Permit Application No.: **18-002**

Rules: **Erosion Control, Wetland Protection, & Stormwater Management**

Applicant: **Wally Marx**
Project: **6 Lot Residential Subdivision**
Location: **2500, 2700, 2702, and 2900 Parkview Drive, Medina**

SCHOOL LAKE NATURE PRESERVE
BUFFER PLANTING, MAINTENANCE & MONITORING PLAN

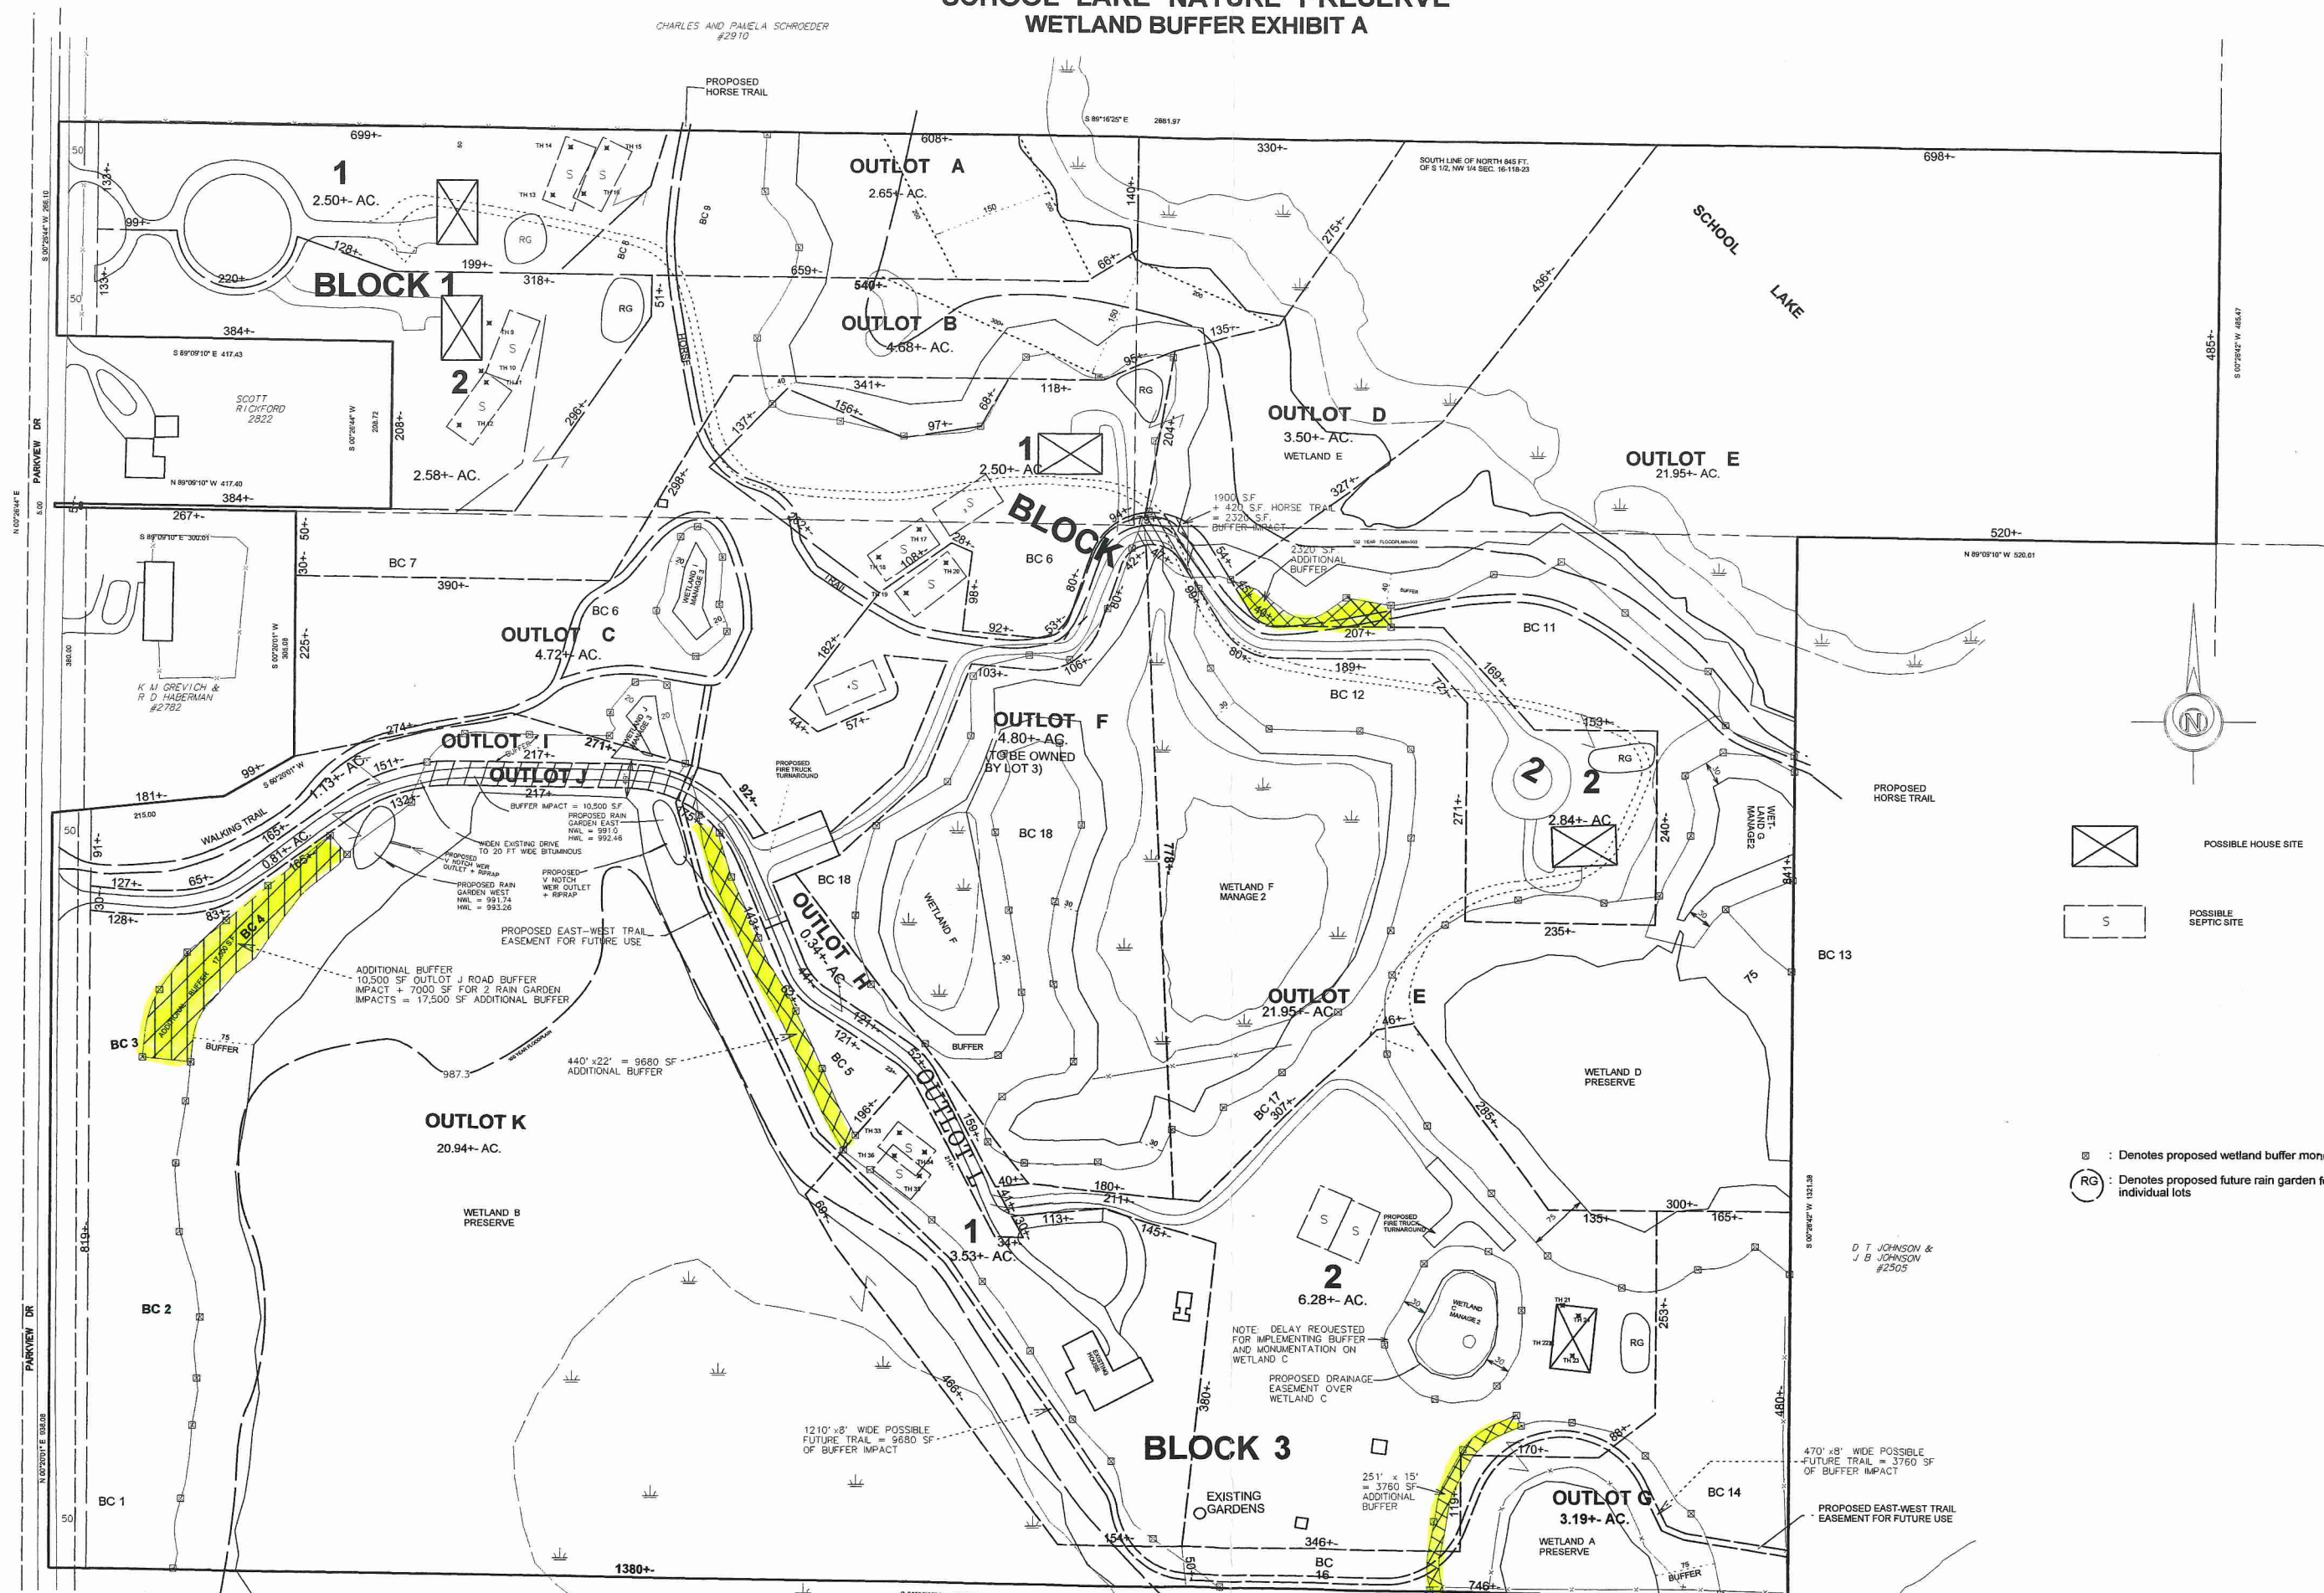
Buffer areas that will be disturbed by construction activities must be revegetated through the decompaction of soils to a depth of 18 inches, planting of native vegetation, and monitoring and maintenance as described in Section 9(h) and Section 10 of the Wetland Protection Rule. The applicant has submitted a vegetation planting, maintenance, and monitoring plan (attachment 5) that meets the requirements of the Rule.
